Reverse engineered  
**Michael Büsch** <m@bues.ch>

Sheet: /  
 File: lf1600.sch

**Title: Xytronic LF-1600**

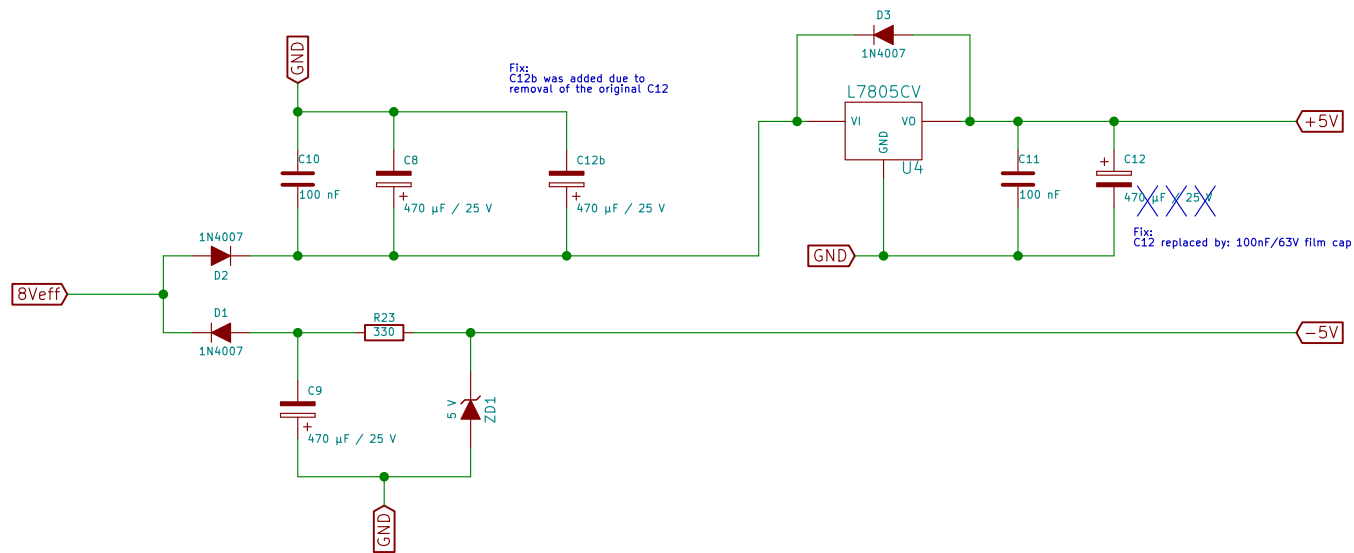
D4 and R9 are not assembled on the board.

Fix: C1b was added, because C1 is far away from VCC/GND pins in older through-hole models.

Sheet: /supply/  
 File: supply.sch

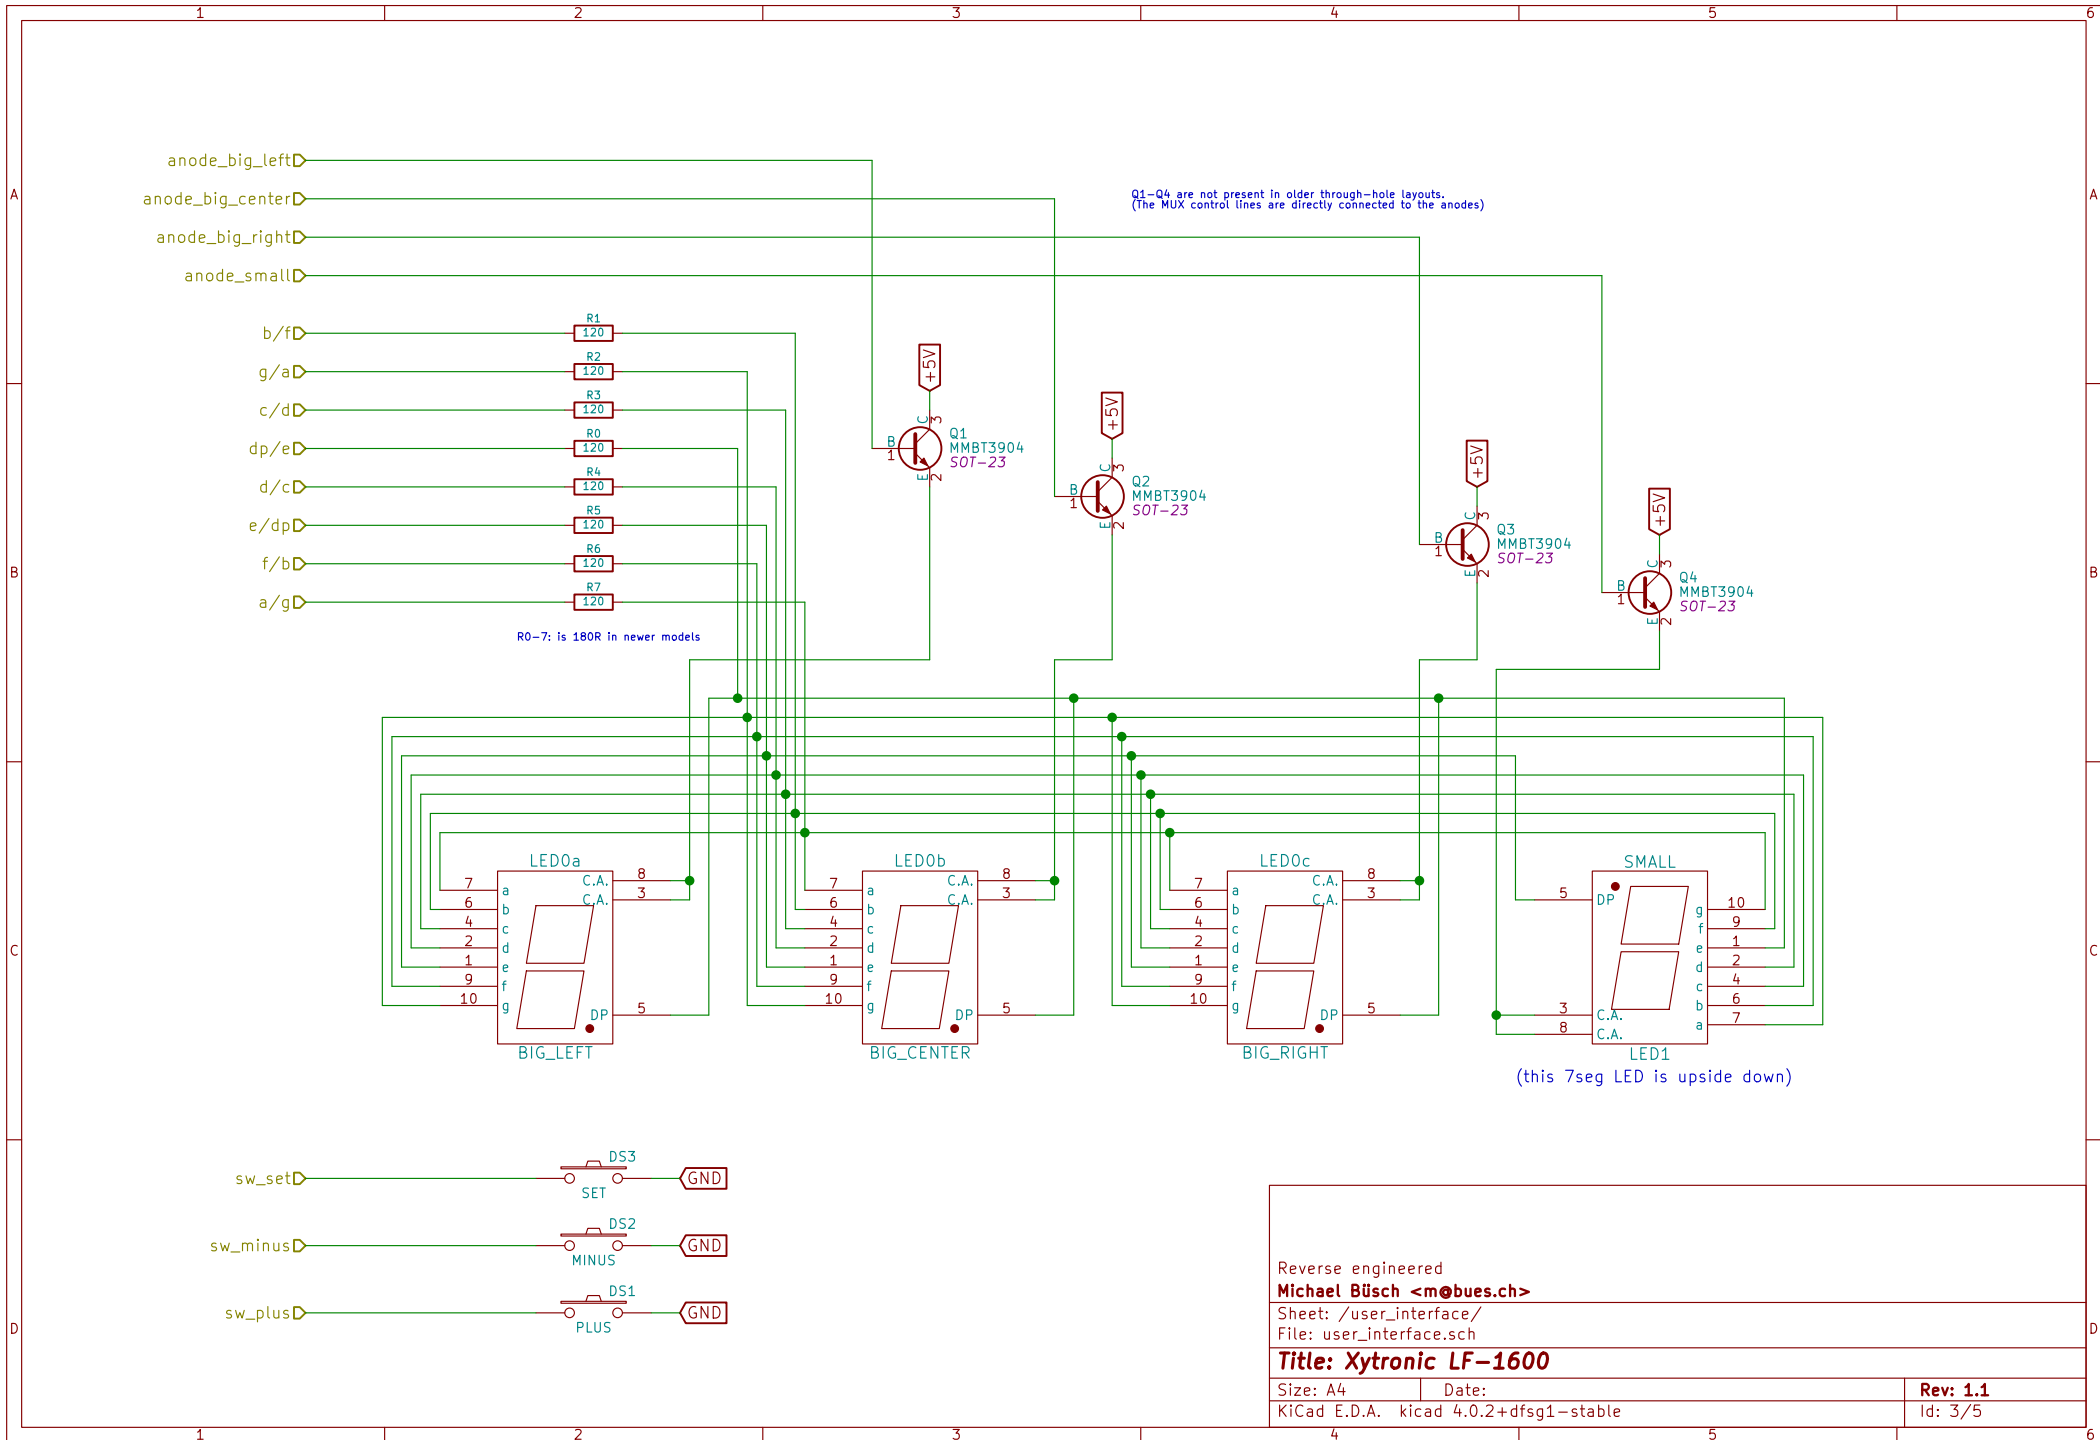
Supply voltage  
 19Veff is not connected  
 24Veff is labeled as "24V", but actually is 31 V (eff)

Fix:  
 C12b was added due to  
 removal of the original C12

Fix:  
 C12 replaced by: 100nF/63V film cap

Sheet: /temperature/  
File: temperature.sch

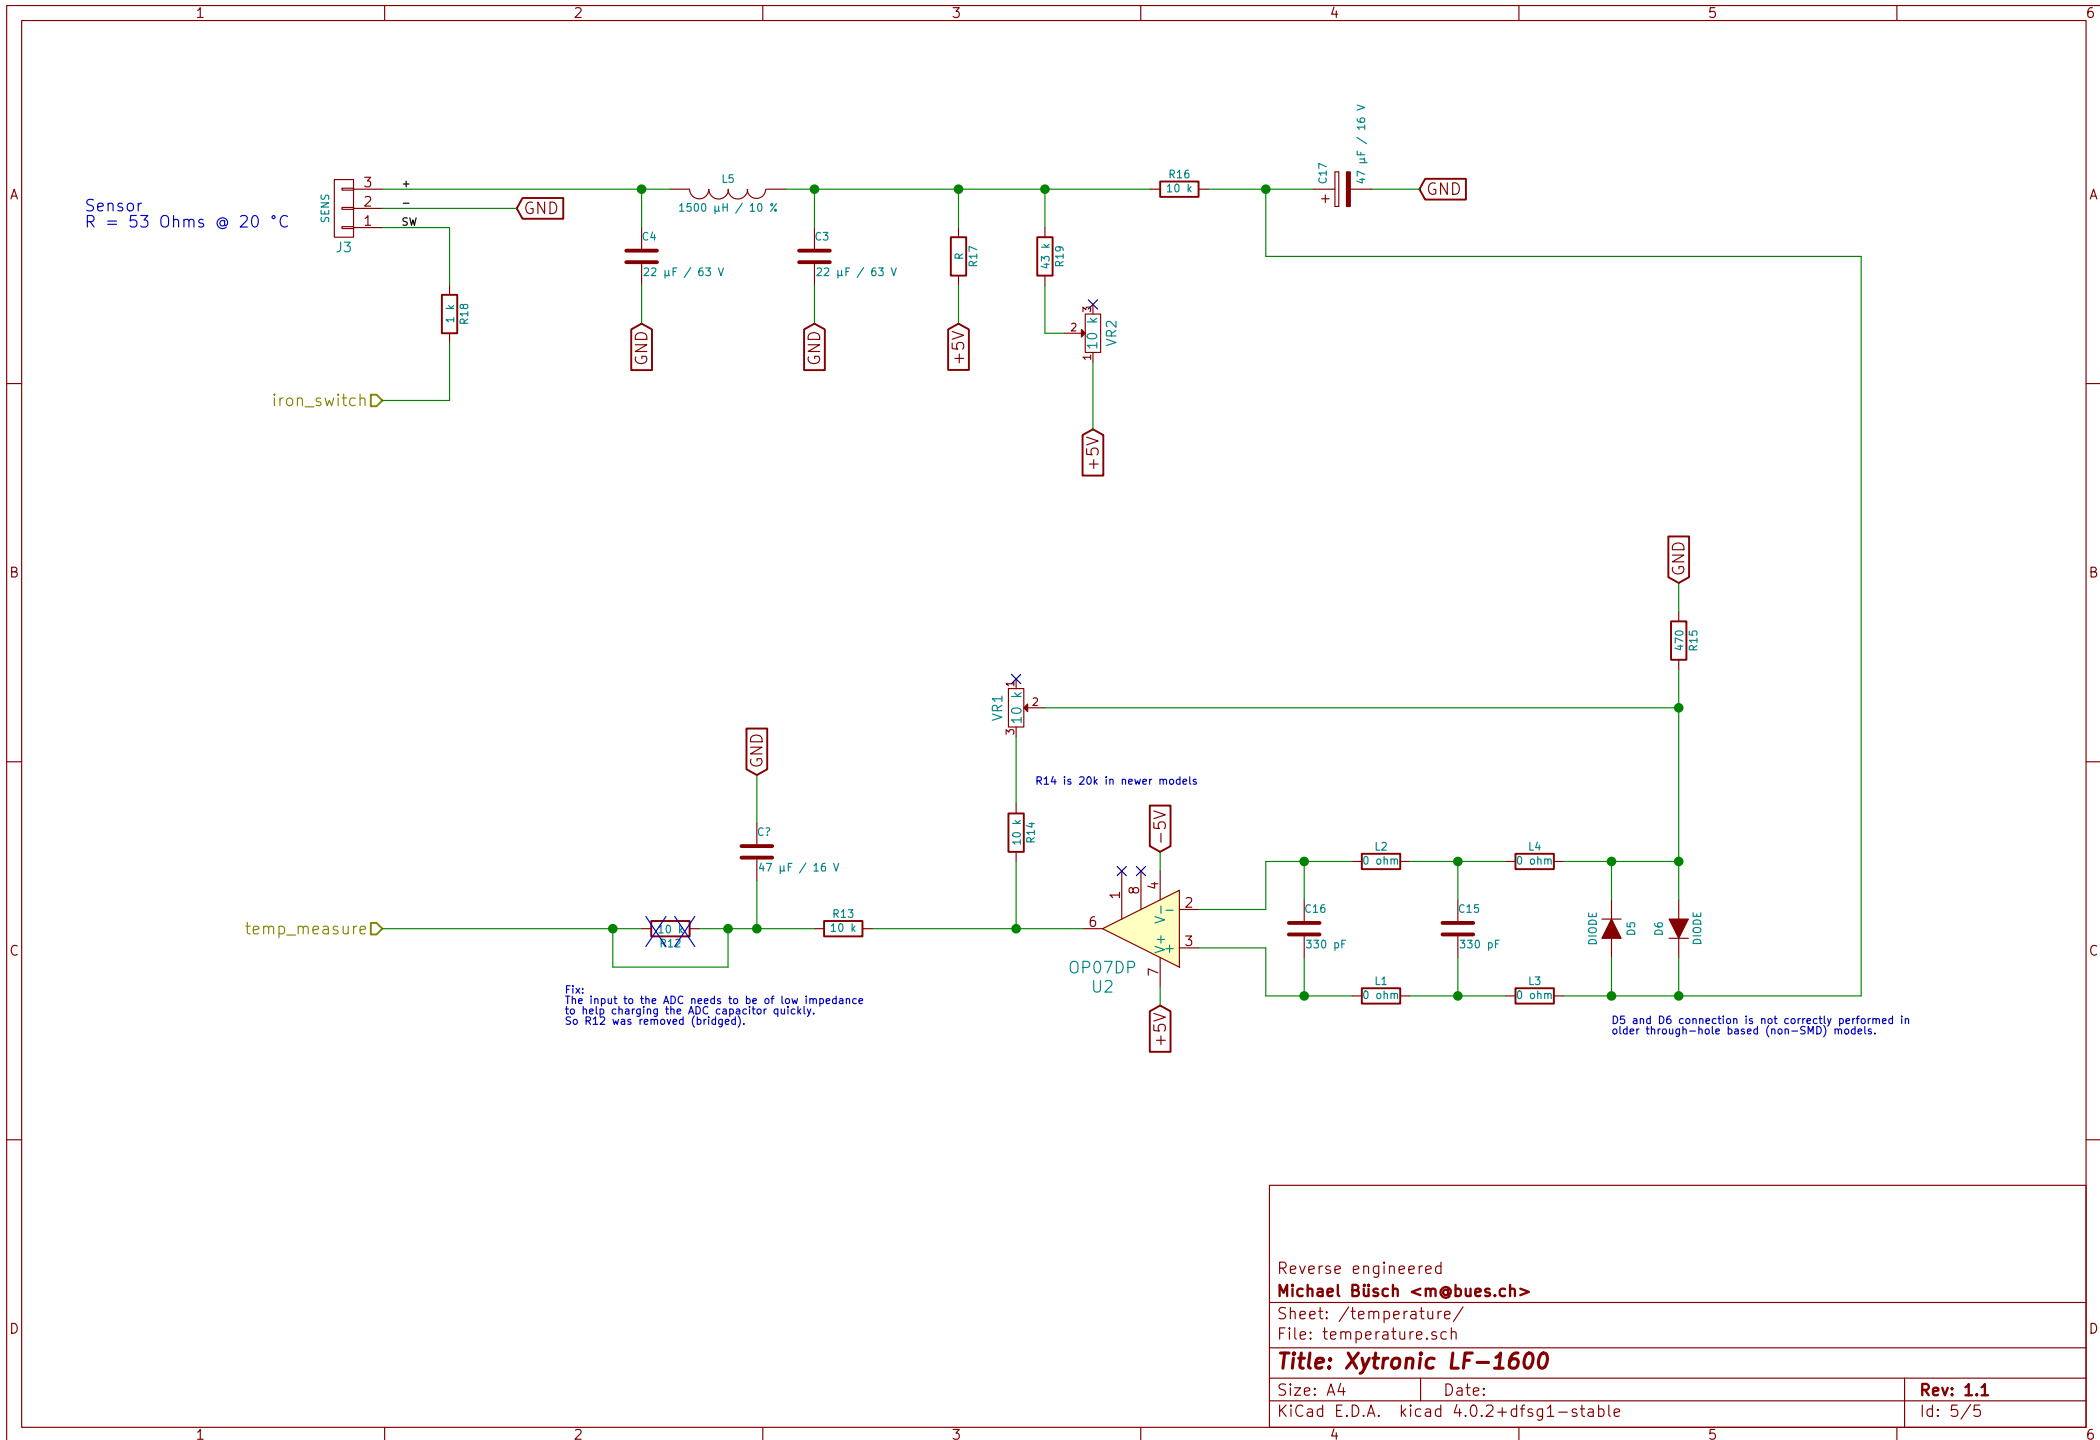
Sensor  
R = 53 Ohms @ 20 °C

R14 is 20k in newer models

D5 and D6 connection is not correctly performed in  
older through-hole based (non-SMD) models.

Fix:  
The input to the ADC needs to be of low impedance  
to help charging the ADC capacitor quickly.  
So R12 was removed (bridged).
